AP1000 CORE REFERENCE REPORT
DCD (Rev. 19) Change Road Map

Change No.	Chapter 15 Section 15.2	Change Summary Description
[15.2-1]	15.2.2, Loss of External Electrical Load	Editorial changes incorporated.
[15.2-2]	15.2.3, Turbine Trip	<p>The following changes were incorporated in the updated analysis: increased $F_{\Delta H}$ limit (1.65 to 1.72), use of the digital ΔT signal, increased rod drop time for the Safety analysis and the updated valve, nozzle and piping pressure loss coefficients.</p> <p>Additionally, the moderator density function was modeled as a function of density.</p>
[15.2-3]	15.2.6, Loss of ac Power to the Plant Auxiliaries	<p>The following changes were incorporated in the updated analysis: increased $F_{\Delta H}$ limit (1.65 to 1.72), containment backpressure effects on PRHR heat transfer, increased rod drop time for the Safety analysis and the updated valve, nozzle and piping pressure loss coefficients.</p> <p>The loss of ac power to the plant auxiliaries case presented in the DCD, where feedwater flow is lost at time zero, and power to the reactor coolant pumps is lost as a result of the turbine trip, was renamed Loss of Normal Feedwater Flow with loss of offsi

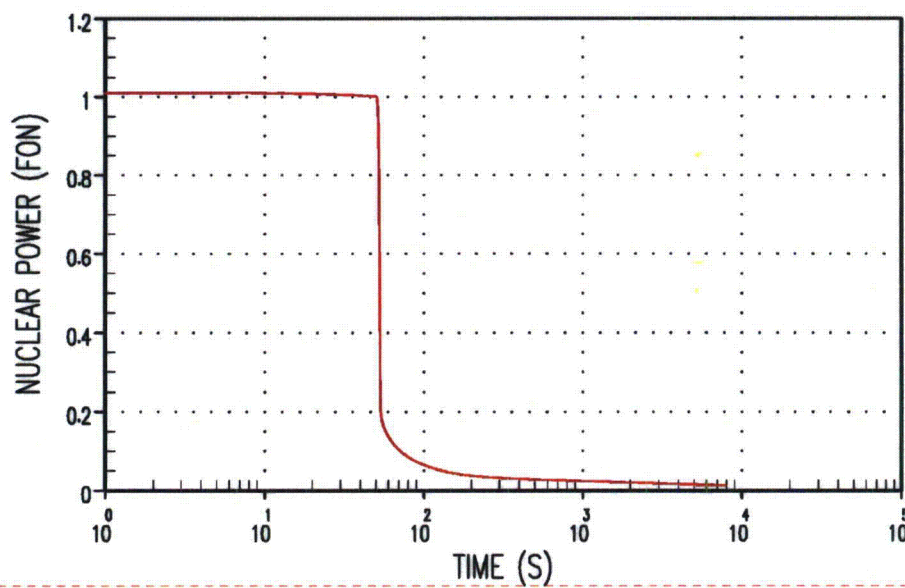
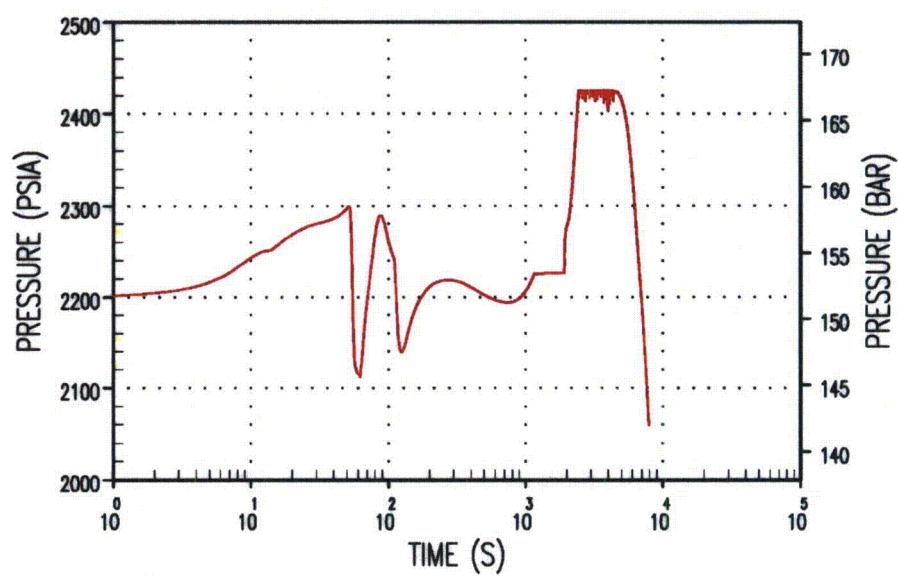
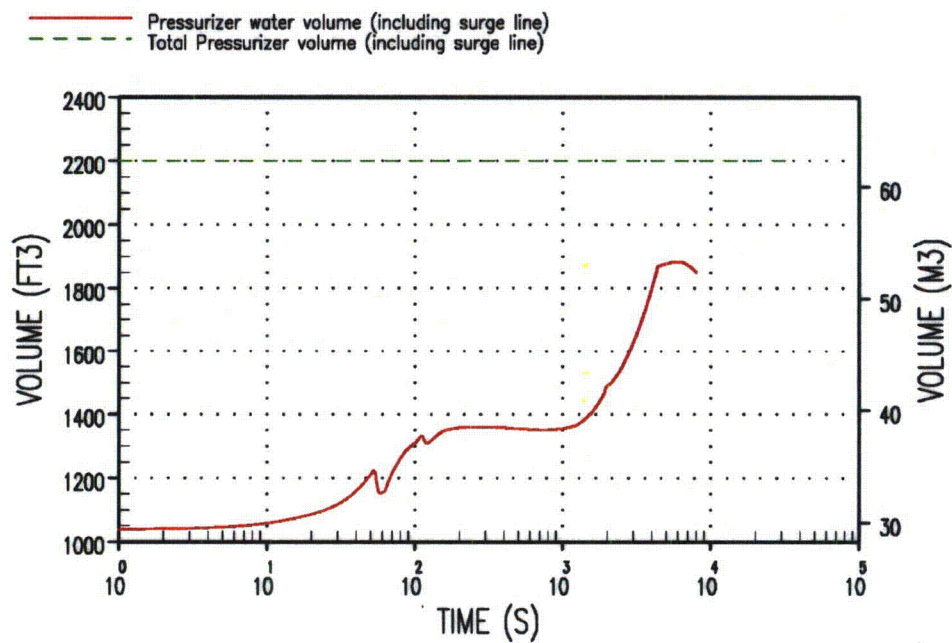
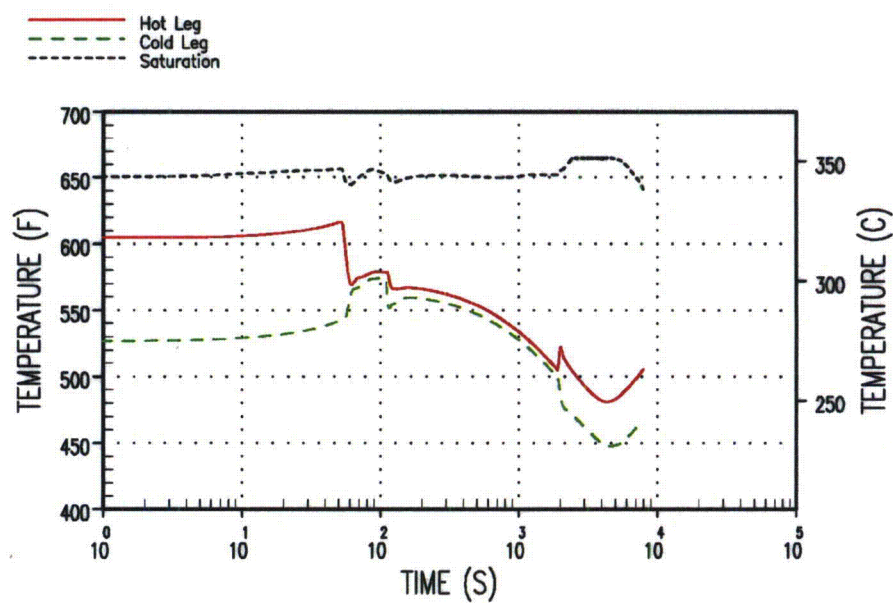
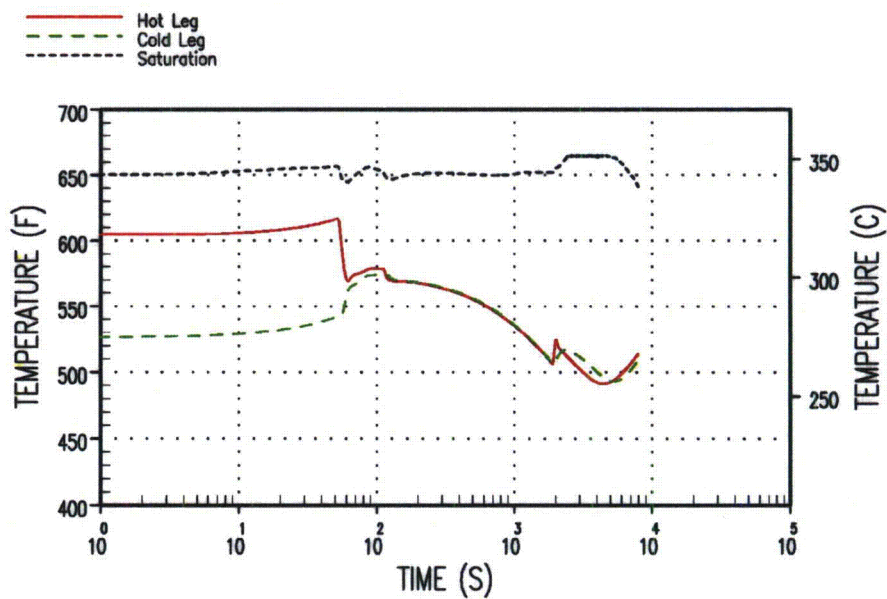
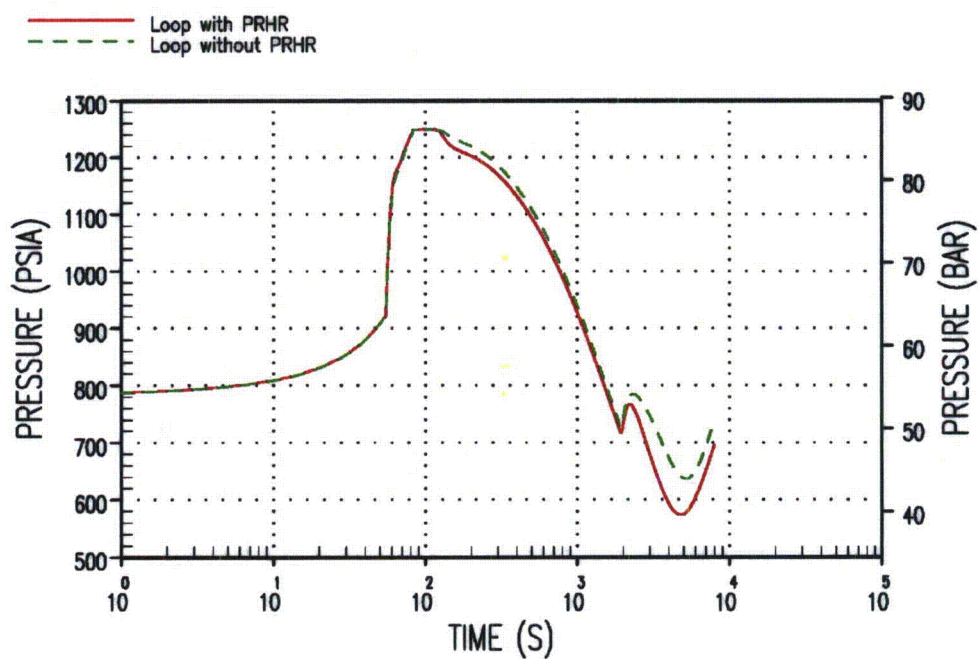
[15.2-6]	15.2.10 References	Added new reference, WCAP-14565 – consistent with the change to Section 15.2.3.2.1
[15.2-7]	Table 15.2-1	Updated in Revision 1 due to revised CVS makeup flows.
[15.2-8]	Figures 15.2.7-1 through 15.2.7-13	Updated in Revision 1 due to revised CVS makeup flows.

Comment [B10]: [15.2-8]

Comment [B11]: [15.2-8]

Comment [B12]: [15.2-8]
